Glebe Farm, Steyning

Comparison Document
November 2025

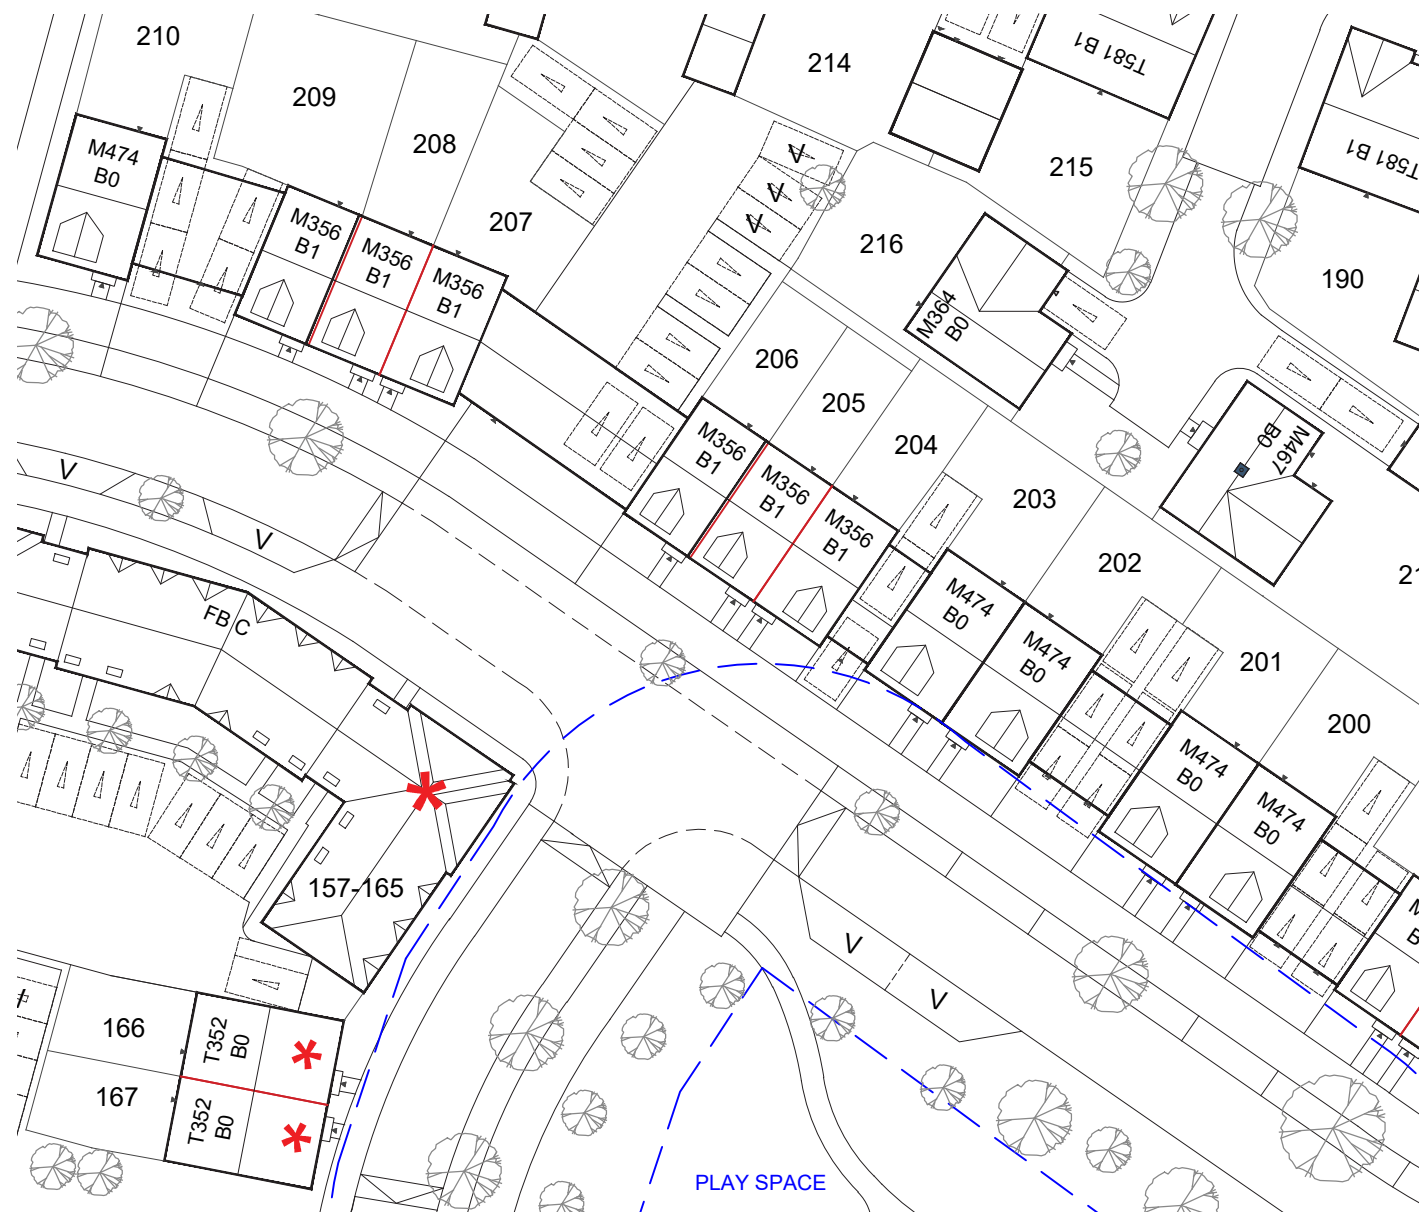
"Distances from plots close to existing properties along King's Barn Lane are closer than preferred by the Council and the Parish, would prefer for the distance to be further."

The plot arrangement has been adjusted to further respect the units adjacent to the site boundary. An additional 6m buffer has been provided from the previously submitted layout.

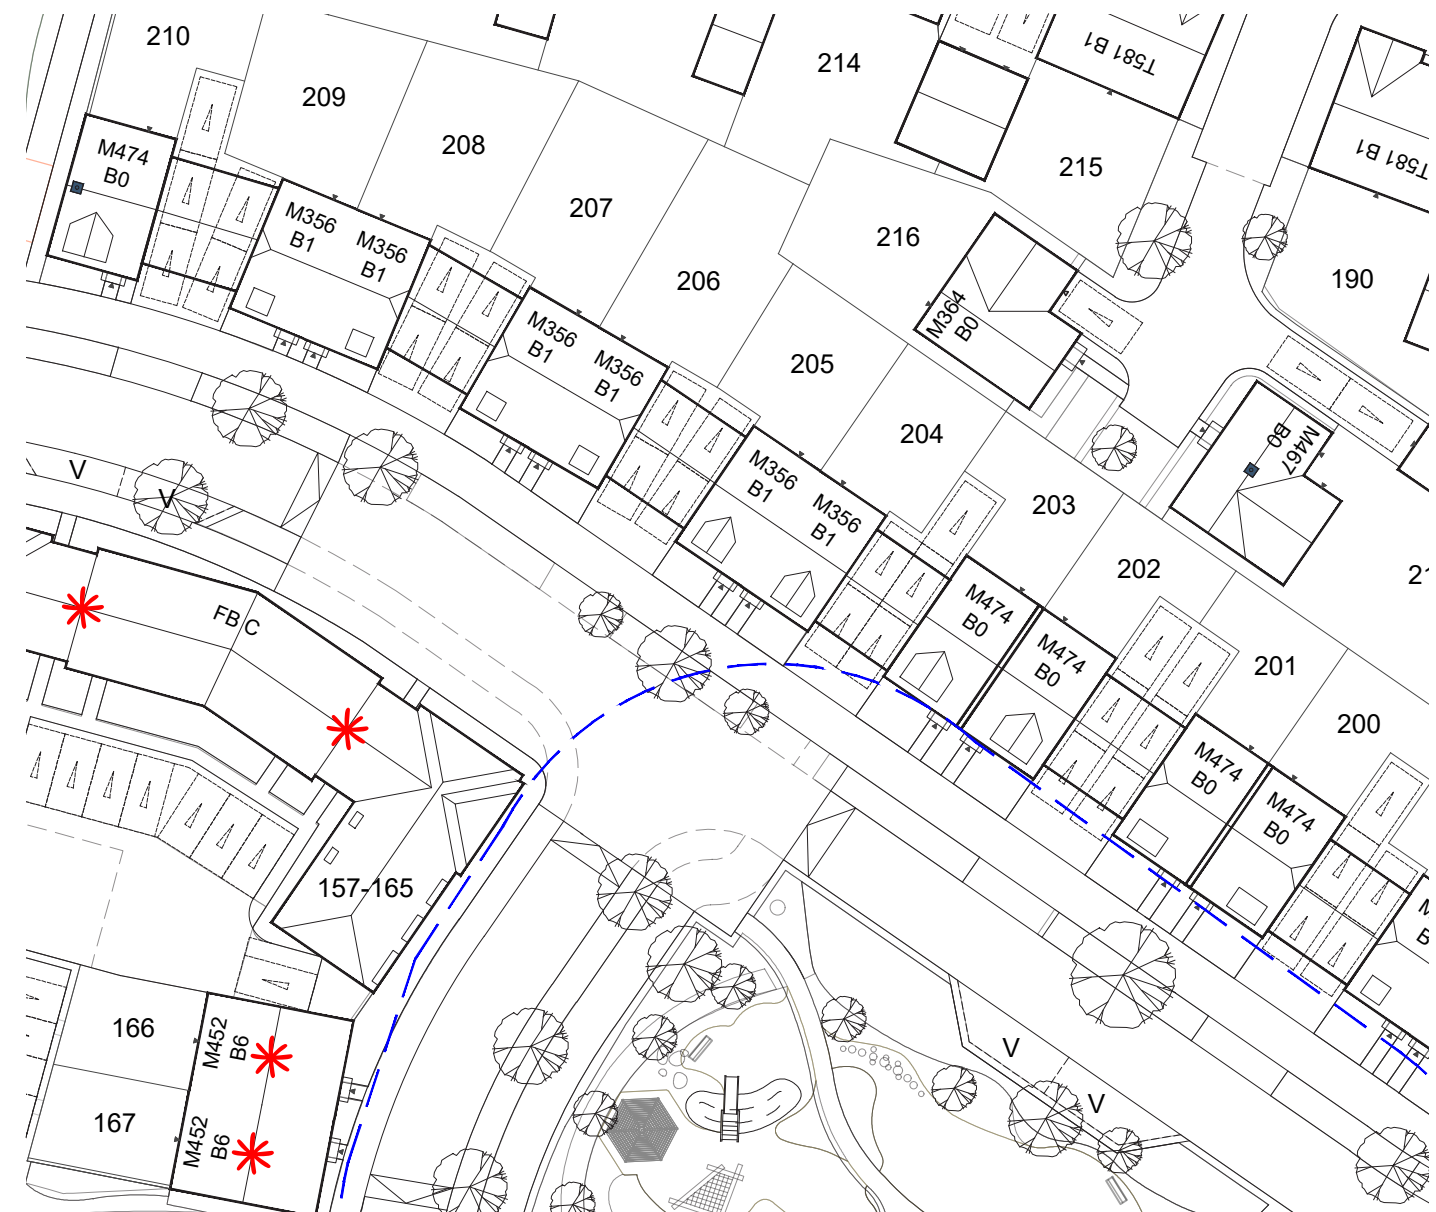
“Principal Street Character Area

Too uniform. More variety in ridge/eaves height as characteristic of Steyning high street was expected (dutch gable?) alongside roof additions/adornment to garage hoods (what is presented is a dilution, please refer to DAS at outline) I could not find elevation detail of the over sail between units 206 -207, please provide."

The Principle Street has been adjusted to introduce differing roof styles, dormer styles and materials. This allows for that previous rigidity to be removed. Further to this, due to the levels, we have been able to introduce the key lack of uniformity that is described within the outline Design Code.

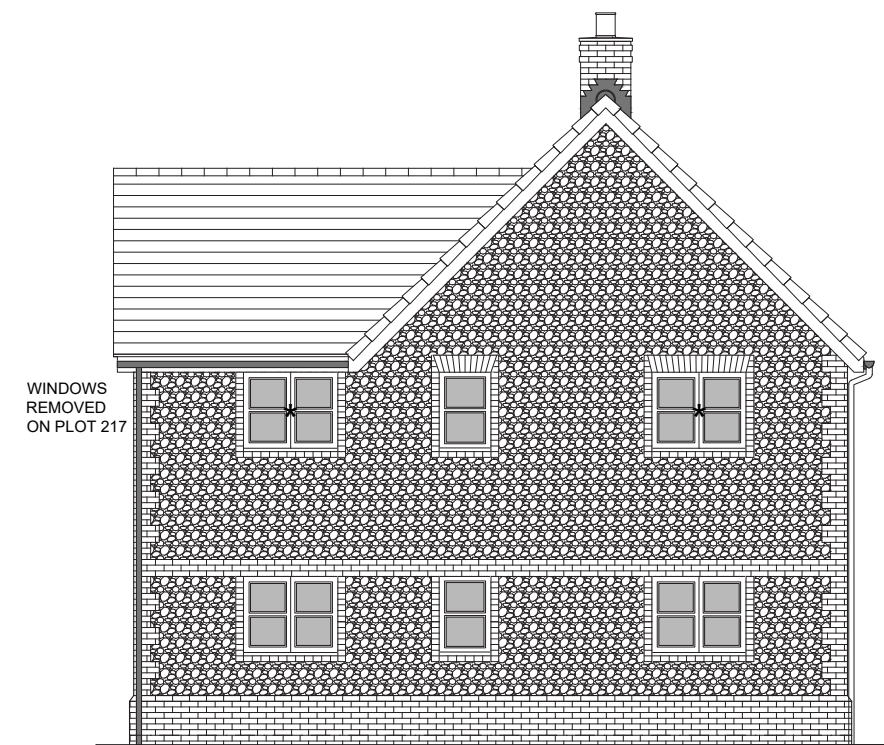
"There are quite a few instances where more opportunity could be taken to improve flank treatments to add to character area qualities, such as larger /more fenestration/ adornments/ complete wrap around boarding rather than arbitrary turn in/ full height exterior chimney breast/stack/ buttress etc."

Key areas where flanking was highlighted have been improved by wrapping the additional material fully round the side elevation allowing a continuous stretch of detail. In other instances, such as House Type 467, large amounts of windows are utilised on the side elevation to provide overlooking onto POS.

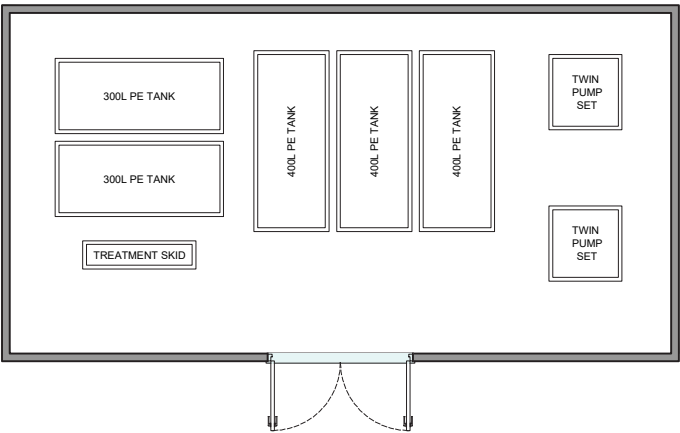
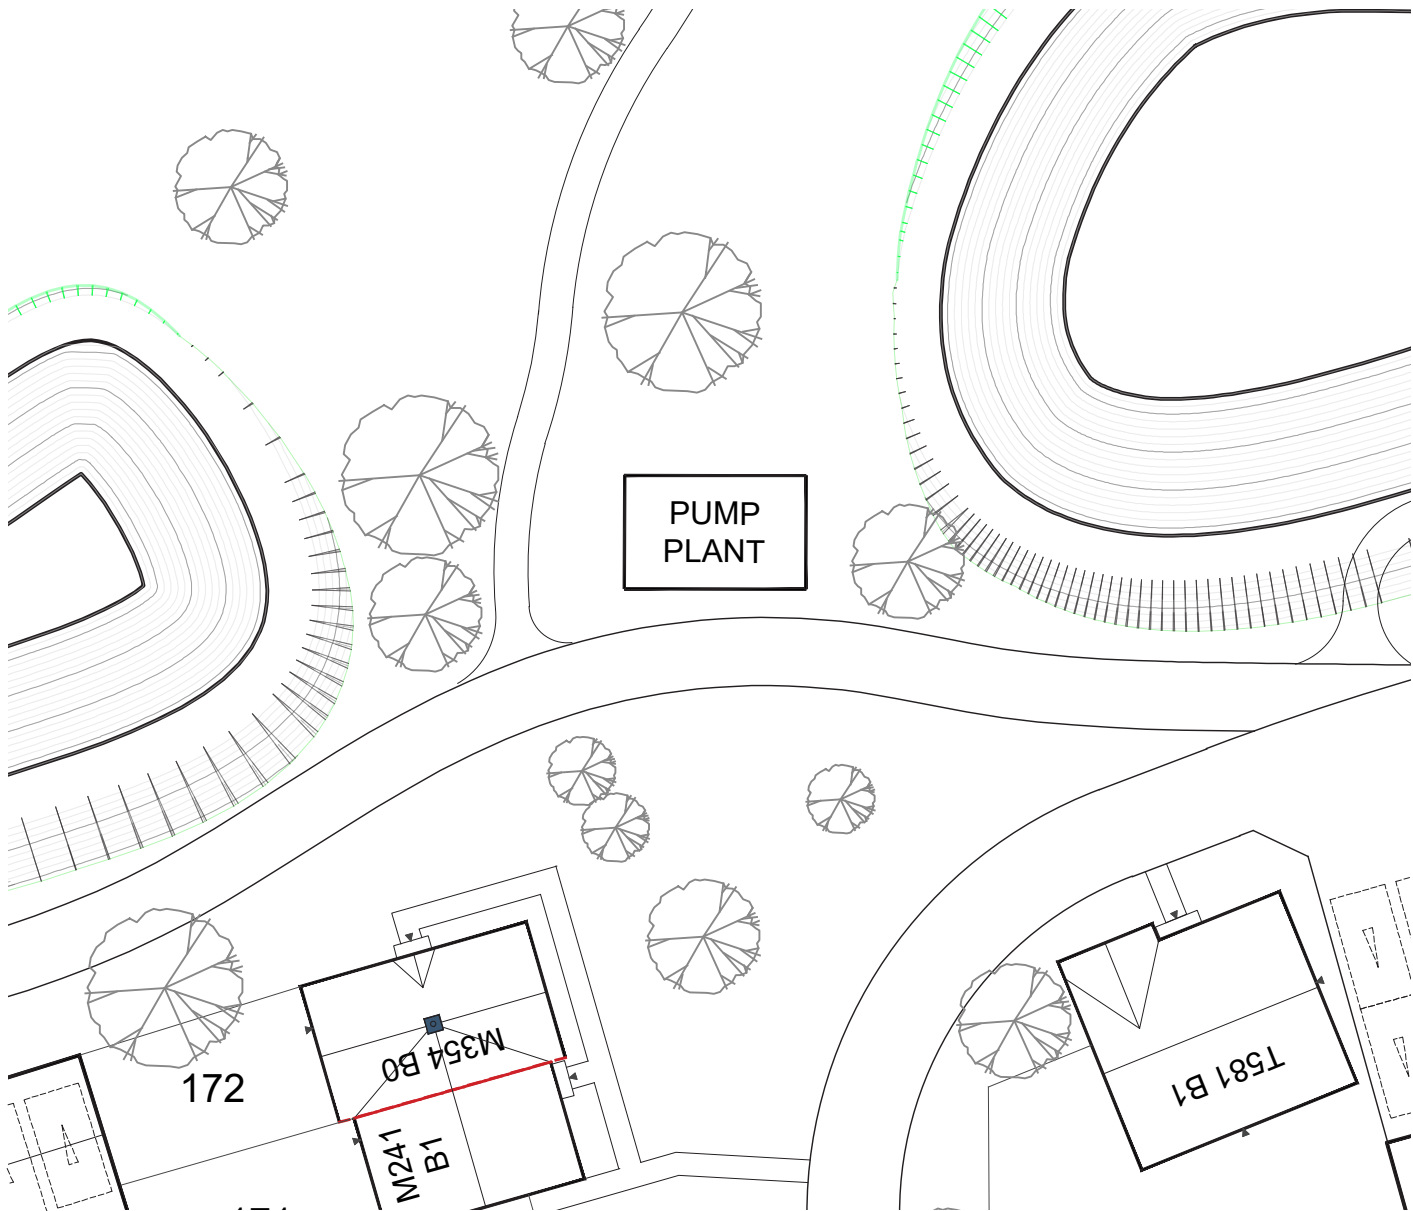
“The position of the pump house is unfortunate. Realise functional drainage systems presents limitations to its location but can it not be explored further? No elevations provided.”

The location unfortunately can’t be changed due to levels and drainage restrictions. We have included elevations and plans in the updated pack showing that the key elevation viewed from the site is adorned with flint to create a more appealing elevational treatment.

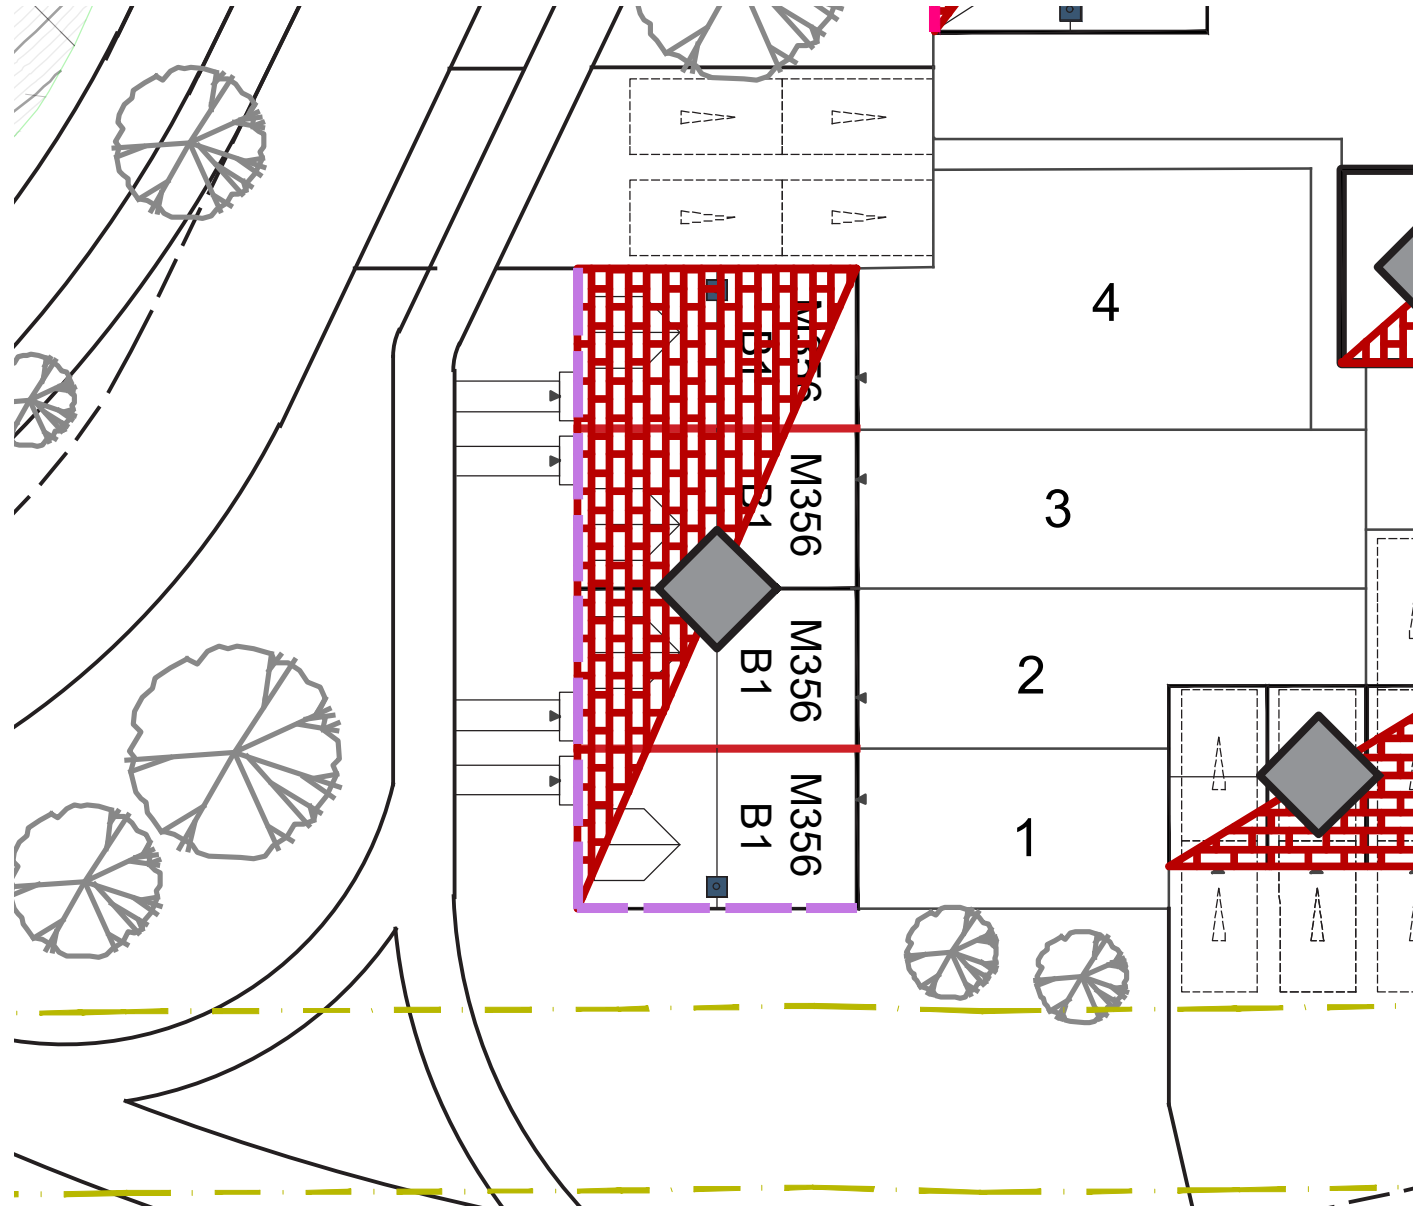
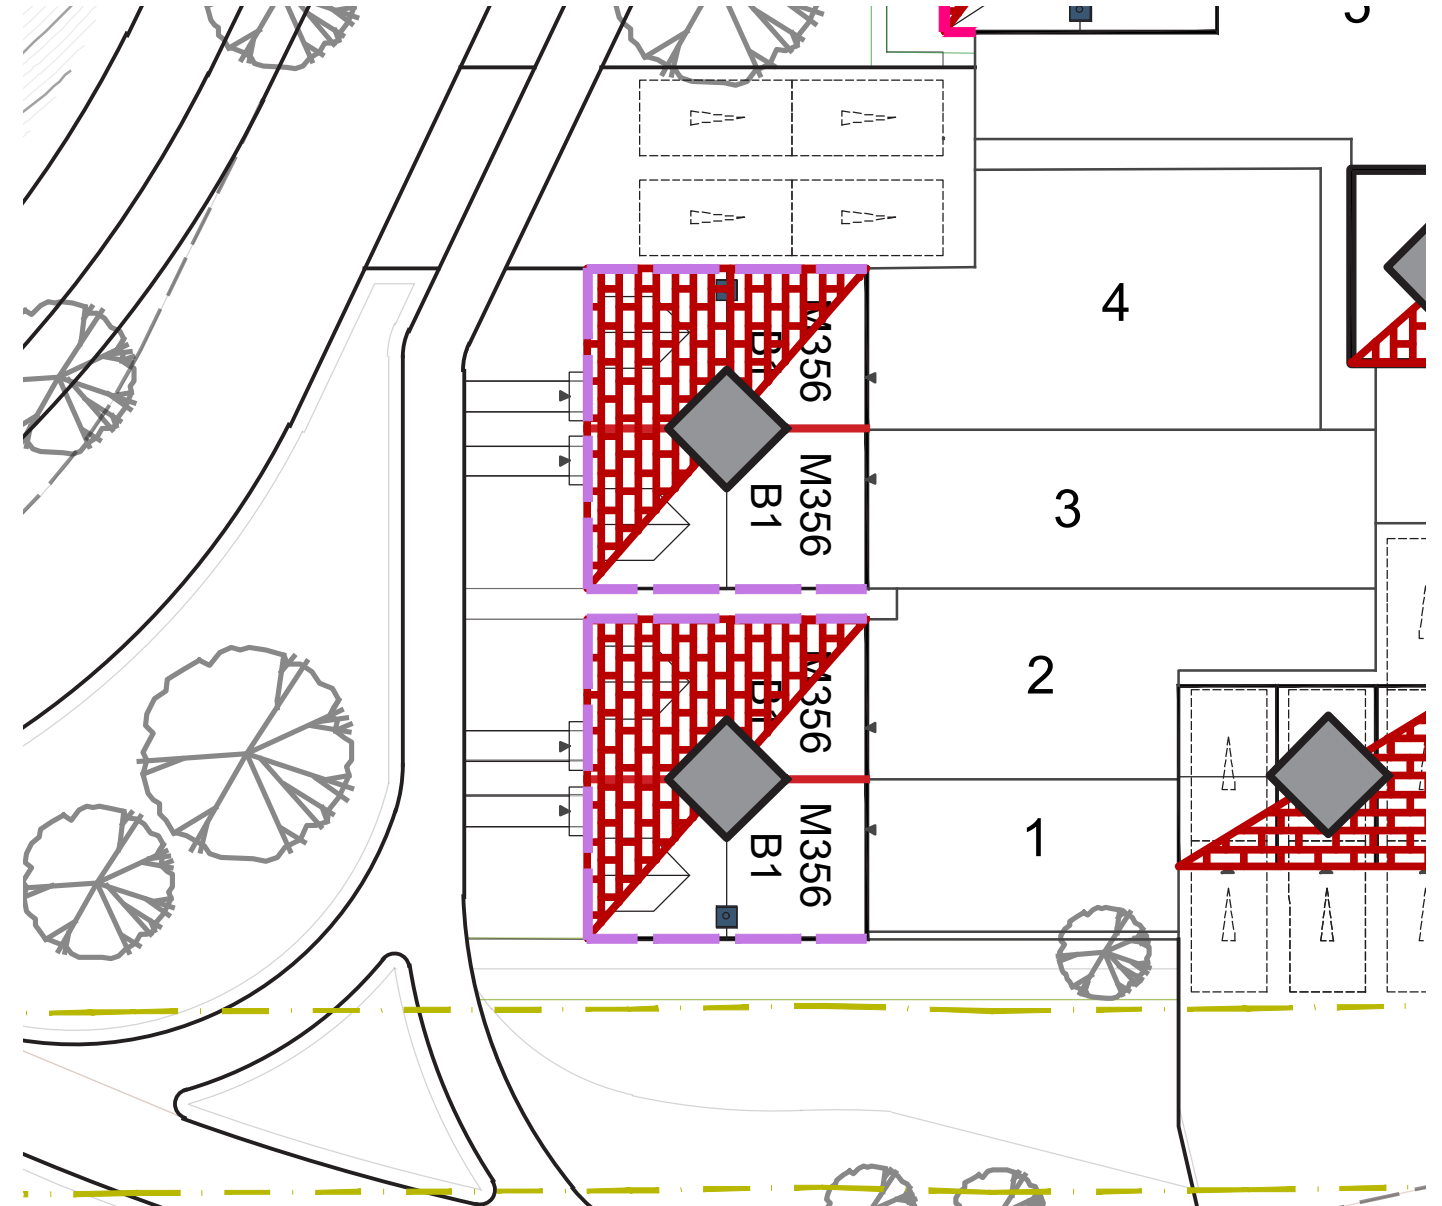
"Where there is instance of flint on units 1 -4, it would be pleasing for all-public frontage elevation receive flint treatment."

The materiality to those additional elevations have been adjusted as per council's request. This has also been implemented across the site.

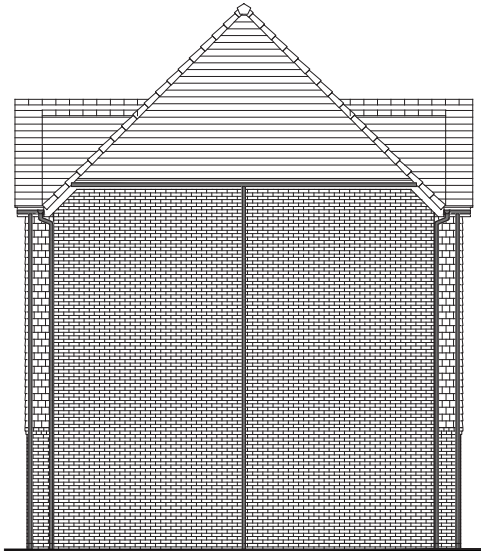
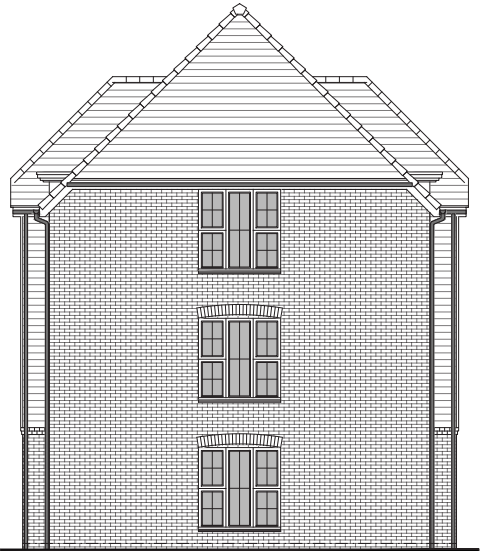
“The relationship in scale between FB B and unit 148 is quite awkward. There should be articulation in west flank.”

The side elevation has been adjusted to provide POS views from the flats to the open space, while providing a more aesthetically pleasing elevation as people access the Roman Road character area.
